TENNESSEE VALLEY AUTHORITY

B65 900928 072

TO : J. E. Varner, Manager, Inspections and Small Projects, BR 4N 83A-C
FROM : Joel D. Paris, Civil Engineer, Site Development, MR 3S 131D-C
DATE : SEP 28 1990
SUBJECT: KINGSTON FOSSIL PLANT - ANNUAL FOSSIL AND HYDRO ENGINEERING (FHE)
INSPECTION OF ASH DISPOSAL AREAS

LOWERING OF DRAINAGE
DITCH TO STOP STANDING
WATER.

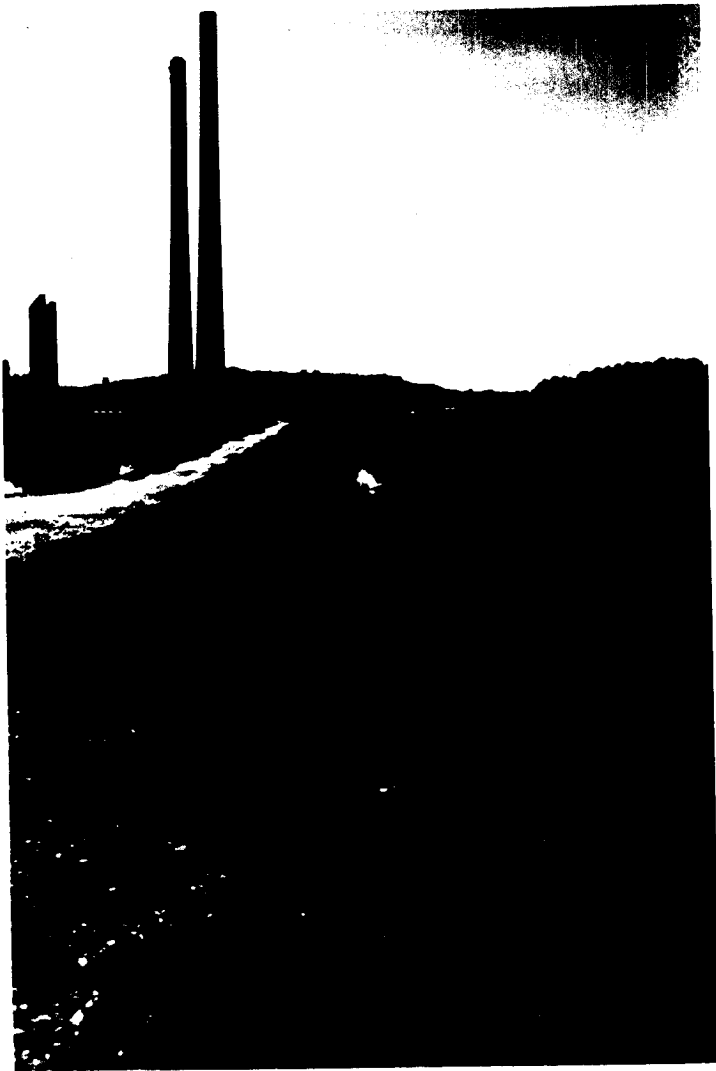
3.7 The original north dike drainage (now south toe of cell 1) has been lowered to remove the ponding. The road crossing at the east end of the ditch was reworked and the pipe lowered four feet. An additional section at pipe was also added (picture 12). This allows an extra four foot fall in the 1800-foot ditch (picture 11).

ASH POND DIKE
PLAN-RAISING ASH DISPOSAL AREA DIKE
KINGSTON STEAM PLANT
TENNESSEE VALLEY AUTHORITY
DIVISION OF ENGINEERING DESIGN
SUBMITTED: [Signature] RECOMMENDED: [Signature] APPROVED: [Signature]
DATE: 5-20-76
KNOXVILLE 5-20-76 36 C ION 420 R

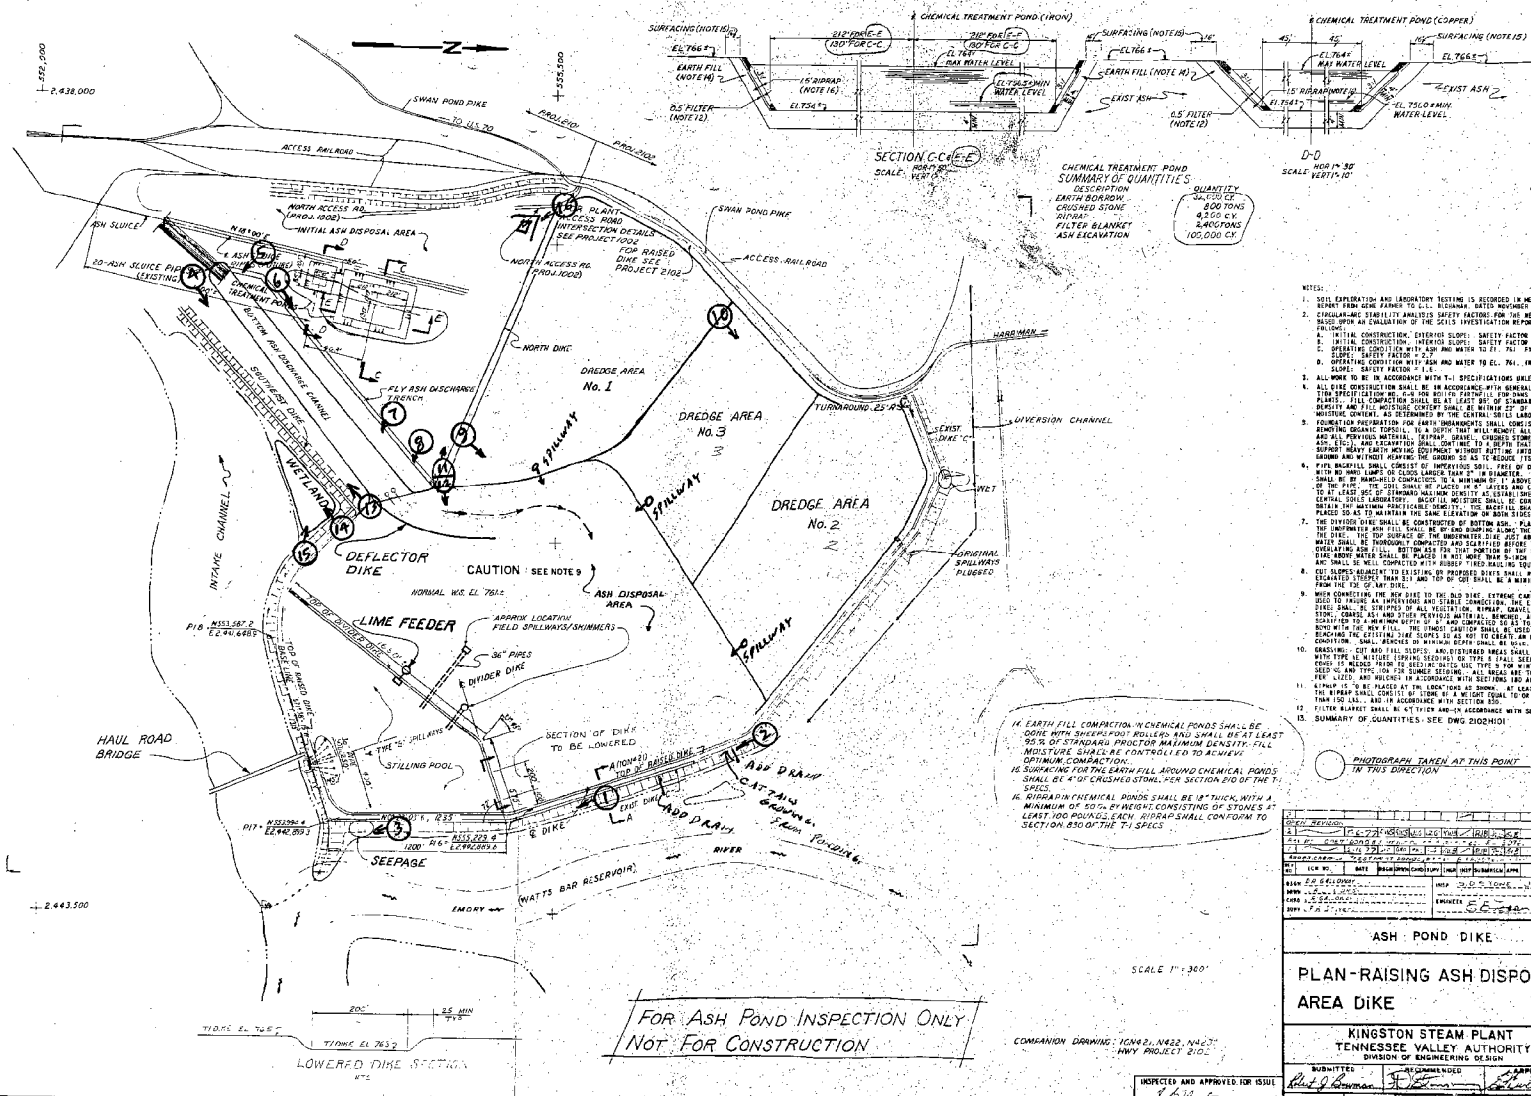
2.1.4 There is a good gravel surface on the dike "C" roads. Additional drainage pipes should be added to add drainage from the berm (see 10N420).

6.2.1 Add two drains under the road (berm) on the north original dike to improve storm drainage.

6.2.1.1 Add one drain at the east end of the island and another one drain at the middle of the island.
